Item ID: D206-781-021L08

Item Name: Floor Protector - Passenger Cabin Clear

DART SERVICE INSTRUCTION

TO AMEND INSTALLATION INSTRUCTIONS IIN-D407-781-1 REV E AND INSTRUCTIONS FOR CONTINUED
AIRWORTHINESS ICA-D407-781 REV 4

FIGURE 1: FLOOR PROTECTOR INSTALLATION

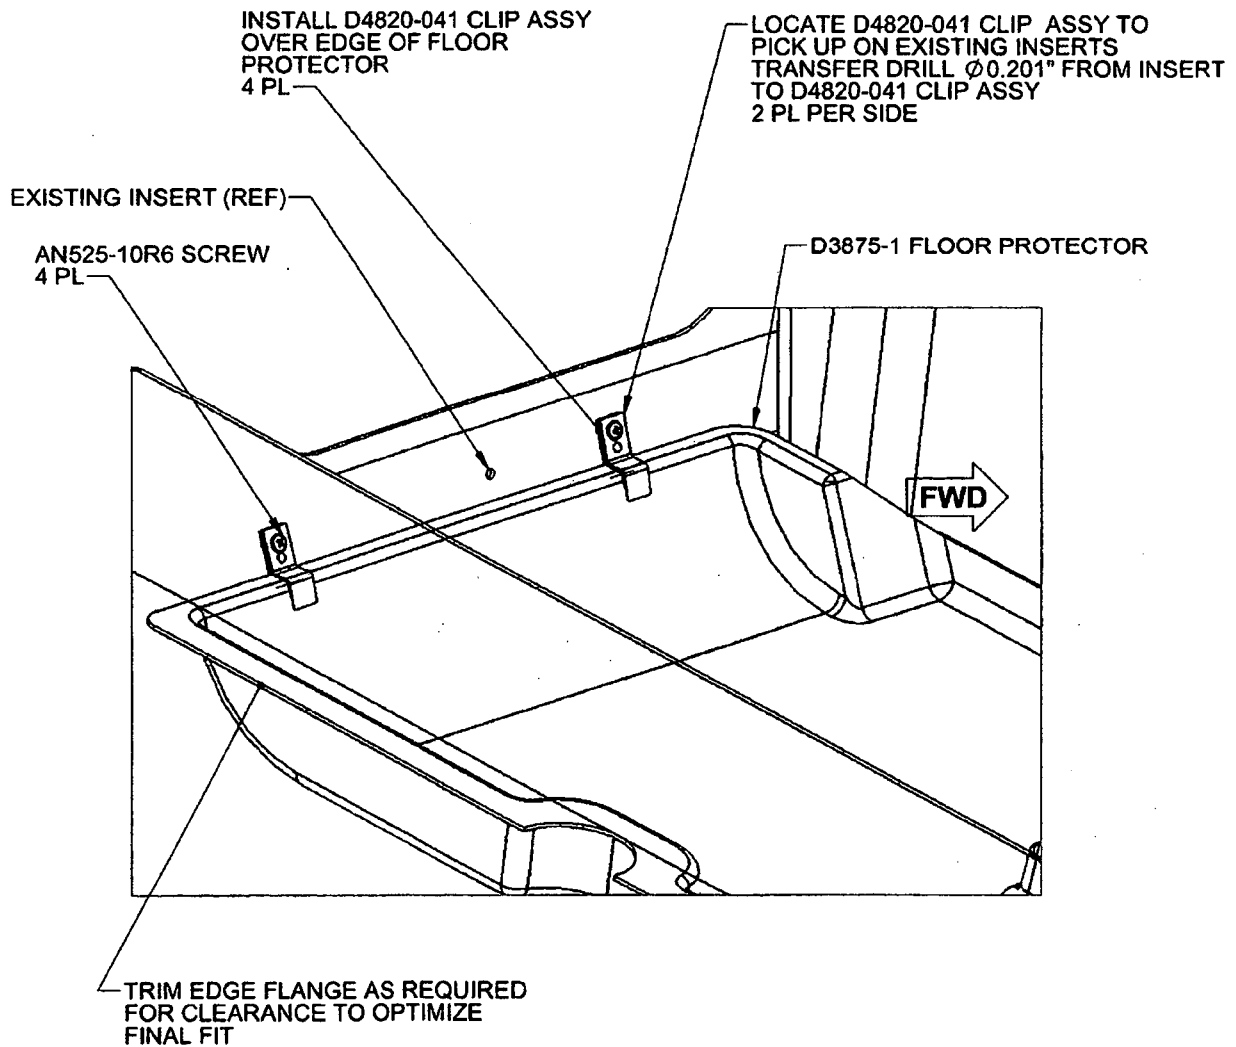
The purpose of this Dart Service Instruction (DSI) is to provide an alternate method of installing the D206-781-021 Floor Protector Kit when it is installed on aircraft without carpets.

2.0 INSTALLATION (refer to Figure 1)

- 2.1 Position the D3875-1 Floor Protector in the passenger area, trimming the edge flanges, as required, for clearance around obstacles and/or to optimize the fit. Ensure there is no debris beneath the protector.

- 2.2 Select the best positions for the D4820-041 Clips to pick up on the existing inserts (2 per side). Press down firmly on the floor protector to ensure it is in full contact with the aircraft floor and transfer mark the hole locations to the D4820-041 Clips.

- 2.3 Drill out the marked holes to $\varnothing 0.201$ and deburr.
- 2.4 Install the D4820-041 Clips (2 per side) using AN525-10R6 screws and secure the D3875-1 Floor Protector. The flat portion of the D4820-041 Clip Assy should slip behind the D3875-1 Floor Protector. Torque the screws to 15-25 in-lbs (1.7-2.8 N-m).

Qty -021	Part Number	Description
X	D206-781-021	FLOOR PROTECTOR KIT (PASSENGER CABIN)
1	D3875-1	FLOOR PROTECTOR, PASSENGER
2	D3934-041	CLIP ASSY
4	D4820-041	CLIP ASSY
4	AN525-10R6	SCREW
2	D3800-1-100-500	LOOP STRIP
2	D3800-3-100-500	HOOK STRIP

Qty -021	Part Number	Description
X	D206-781-021	FLOOR PROTECTOR KIT (PASSENGER CABIN)
1	D3875-1	FLOOR PROTECTOR, PASSENGER
2	D3934-041	CLIP ASSY
2	AN525-10R6	SCREW
2	D3800-1-100-500	LOOP STRIP
2	D3800-3-100-500	HOOK STRIP
